Jaguar-Daimler	OCTOBER 1972 SECTION: N		
IMPART	BULLETIN: 21 ISSUE: 2		
	Page 1 of 1

SUBJECT:- BRAKE PAD KITS (SLOTTED TYPE).

6	Jaguar – Daimler		Volume J3
Y	Parts Technical Info	Number J12 December 1978	
Leyland Cars Service and Parts Division		British Leyland UK Li Jaguar & Rover Trium P.O. Box 150, Fletcha Coventry CV4 9DB	ph, Parts & Accessories
Item 63			
SUBJECT:	ACTUATOR KIT		
MODELS:	Series 3 E Type Open	Literature affected Catalogue Transparency RTC9014 JMF2/E RTC9015 JMF2/E	
MODIFICATI	ON: Introduction of a kit, containing pressure differenti replaces the existing unit.	al warning actuator valve and	spacer, which
PART NUMBER:	Part No. Qty. Description	Existing Part No. Rema C.37217	rks
NOTE:	The kit contains actuator TKC2449 and spacer BD.27	907

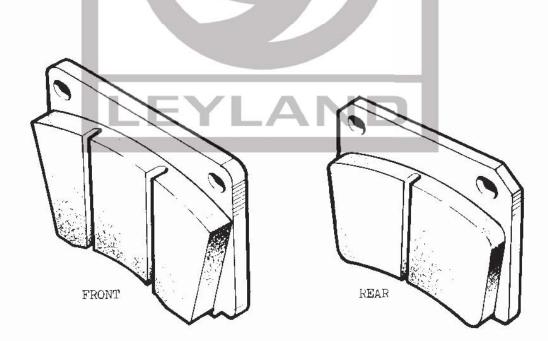
From the above Chassis Numbers revised Brake Pad Kits were fitted. Details are as follows:-

The revised Pads are identified by slots, as illustrated below :-

Part No.		Description.	Qty.	Remarks.
0.39136	+	Front Brake Pad Kit (4 Pads), for Front Calipers	1	
0.39137	+	Rear Brake Pad Kit (4 Pads), for Rear Calipers	1

SUBJECT: REAR BRAKE DISC

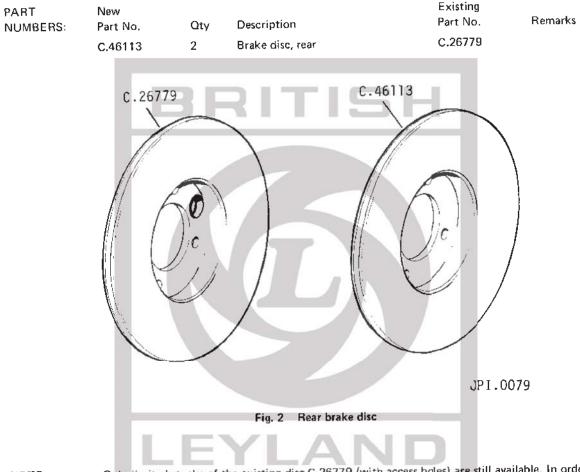
MODIFICATION: Introduction of modified rear brake disc deleting the access holes for the caliper mounting plate bolts.

- NOTE: Only limited stocks of the existing disc C.26779 (with access holes) are still available. In order to avoid creating an out of stock situation Distributors and Dealers are requested to use the new disc as a replacement on earlier models which do not require the access holes. The model applicability for both discs being as follows:—
  - C.26779 = Jaguar S Type, 420, 4.2 litre Mark 10,420G, 4.2 litre E type, Series 2 E type Daimler Sovereign (pre '69), Limousine.
  - C.46113 = Jaguar XJ6 series 1 and 2, XJ12 series 1 and 2, Series 3 E type, XJ-S Daimler Sovereign series 1 and 2, Double-Six series 1 and 2.
